June 5, 2025

# Planning Commission

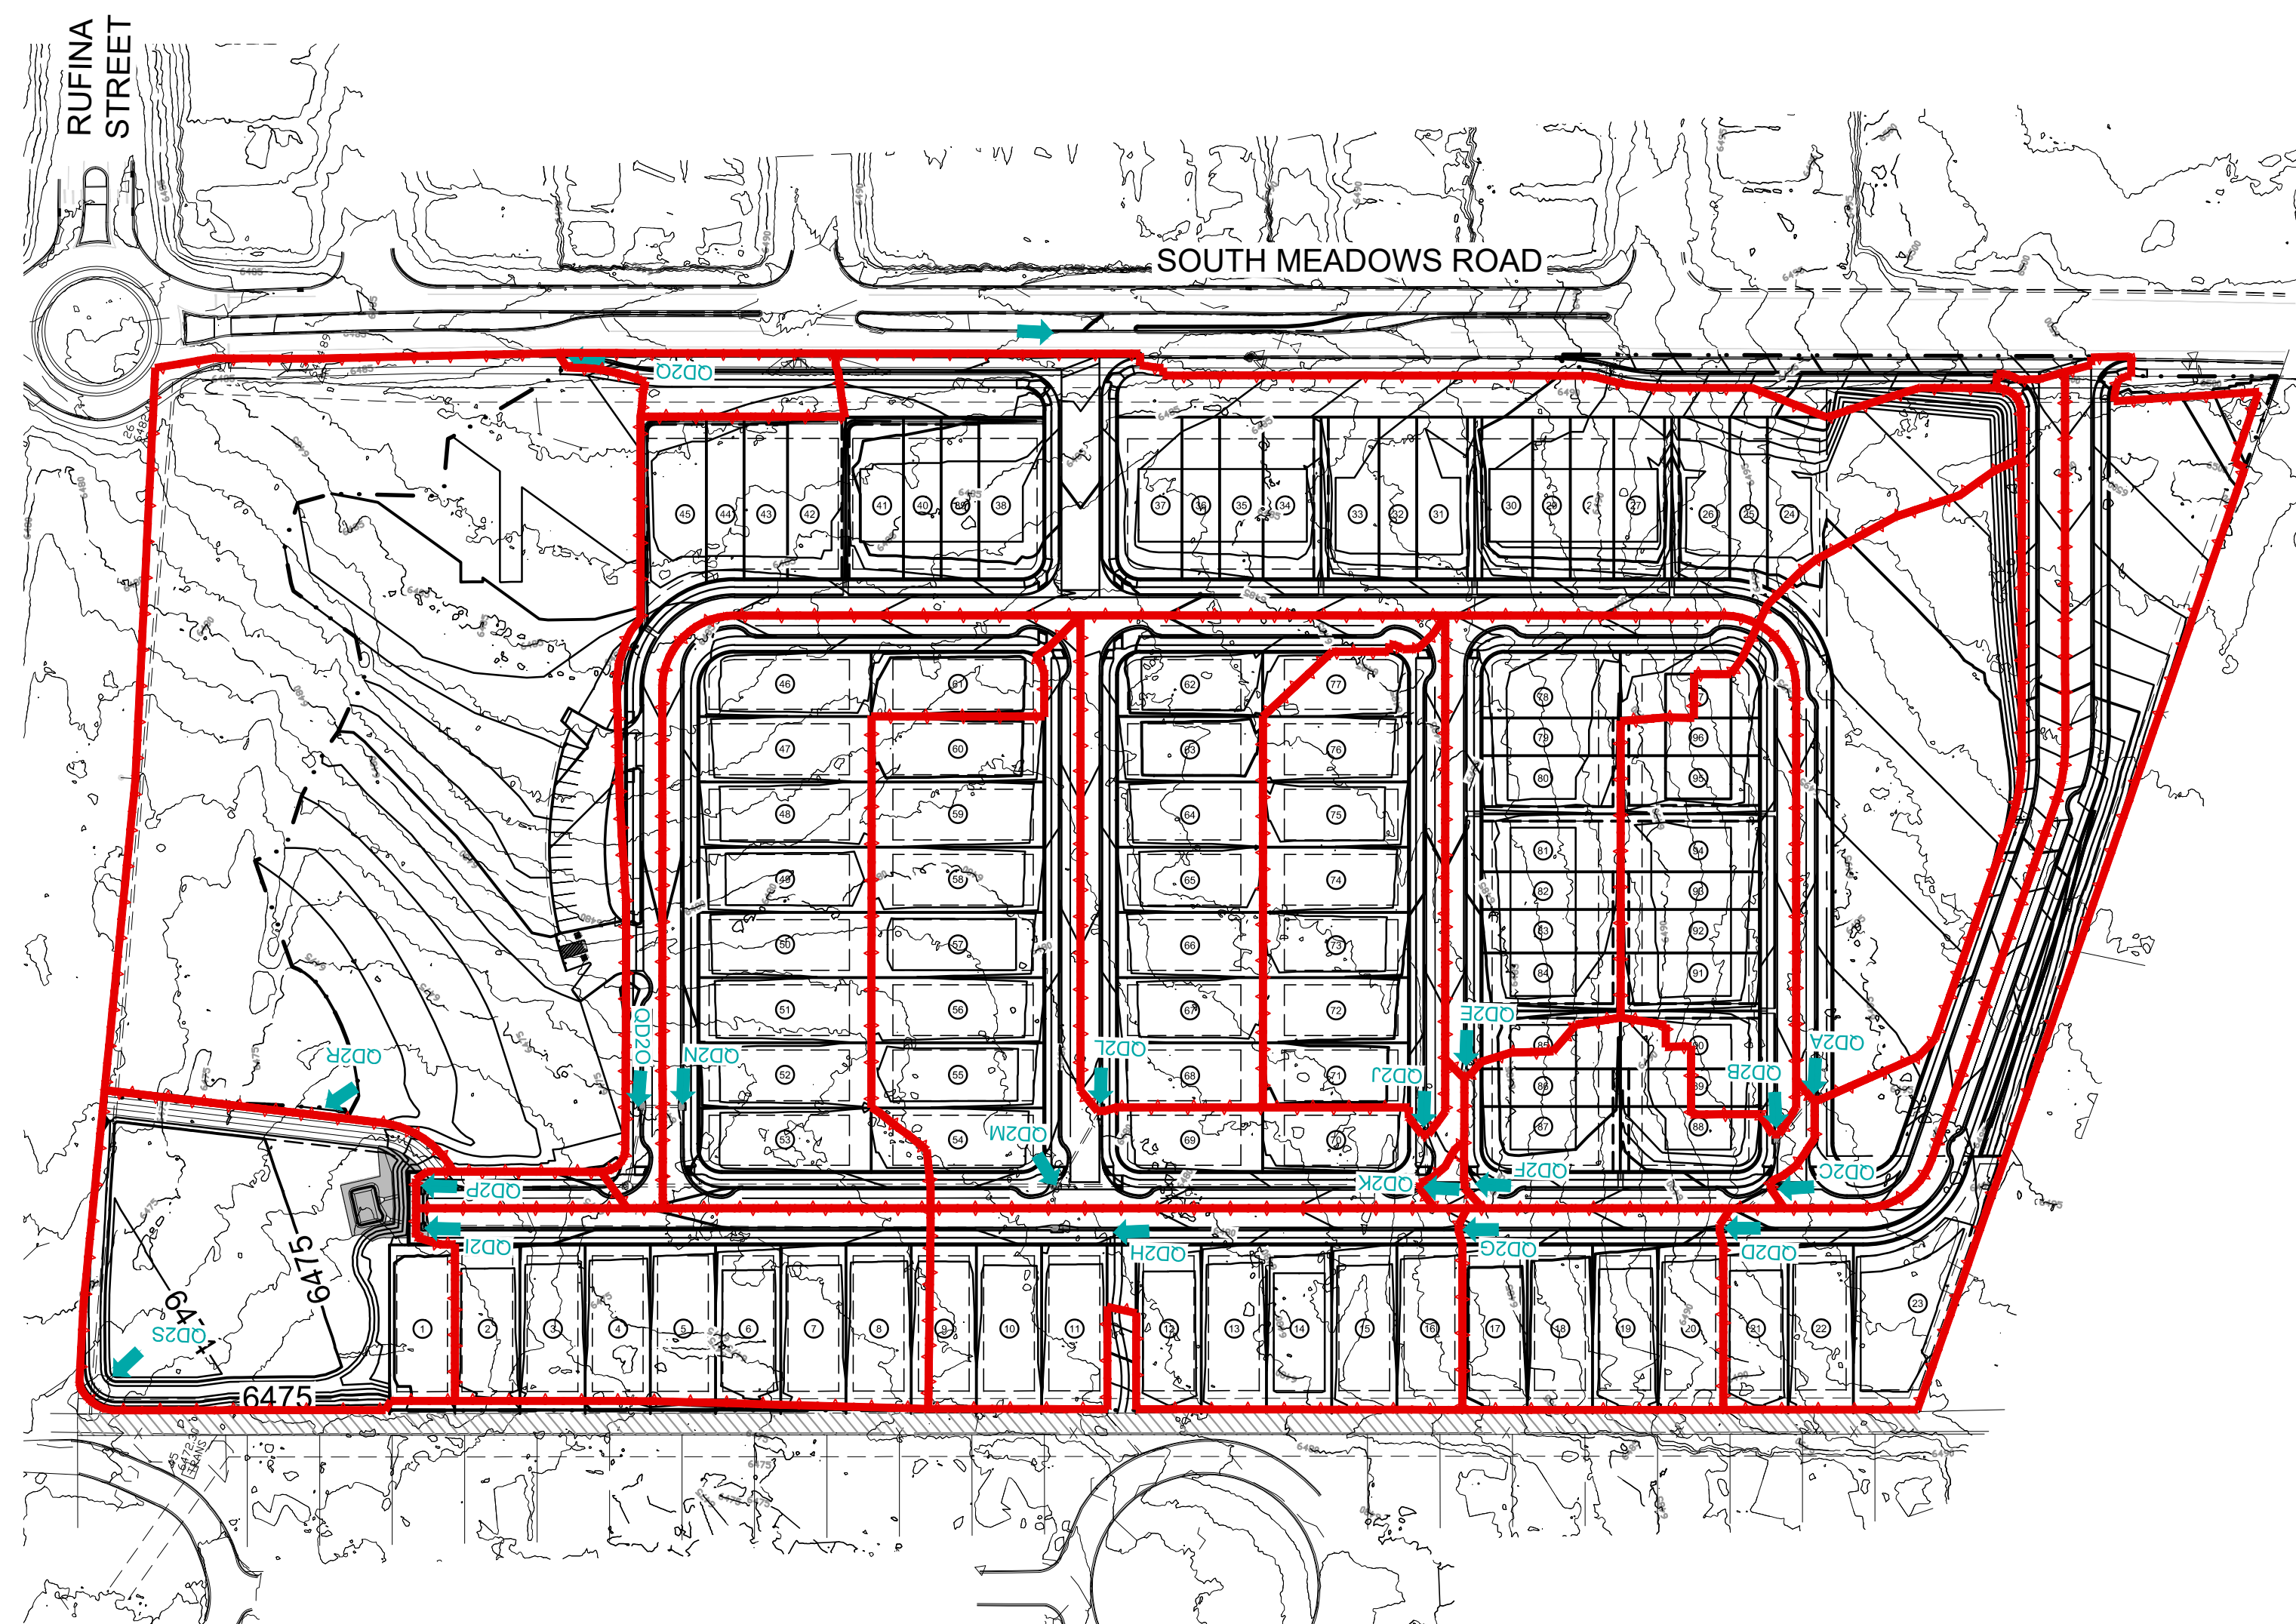
Project Name: \_\_\_\_\_  
 Purpose of Inspection: \_\_\_\_\_ Date: \_\_\_\_\_  
 Inspector: \_\_\_\_\_  
 Weather Information: Type, Time, Amount, and Duration of Each Storm Event since Last Inspection. List Dates and Location for Storm Events:  
 \_\_\_\_\_  
 \_\_\_\_\_  
 Location of NPDES Notice of Permit Coverage Posting: \_\_\_\_\_  
 \_\_\_\_\_  
 Has Land Disturbance Log been maintained:  Yes  No  N/A  
 Does the site map reflect current BMPs and Site Characteristics?  Yes  No  
 Does the site map reflect current BMPs and Site Characteristics?  Yes  No  
 Comments: \_\_\_\_\_  
 \_\_\_\_\_  
 Evidence of Discharges of Sediment or other Pollutants from the Site (Describe Below):  Yes  No  
 Evidence of Spills or Leaks (Describe Below):  Yes  No  
 Evidence of Offsite Sediment Tracking (Describe Below)  Yes  No  
 Comments: \_\_\_\_\_  
 \_\_\_\_\_  
 Is Facility in Compliance with SWPP Plan and Permit?  Yes  No

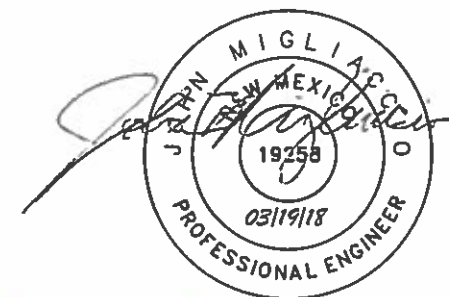
REVISIONS (OR CHANGE NOTICES)

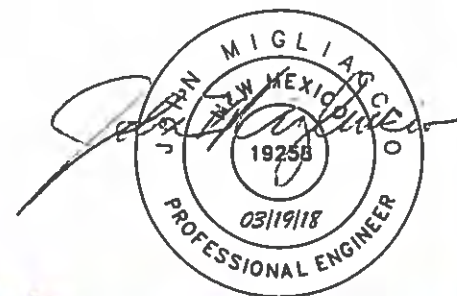
REVISIONS (OR CHANGE NOTICES)

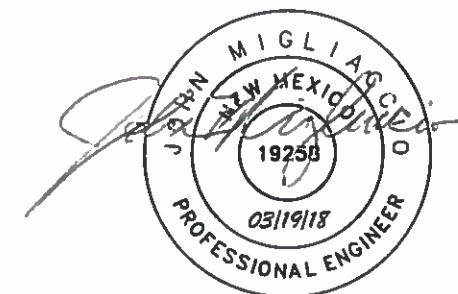
REVISIONS (OR CHANGE NOTICES)
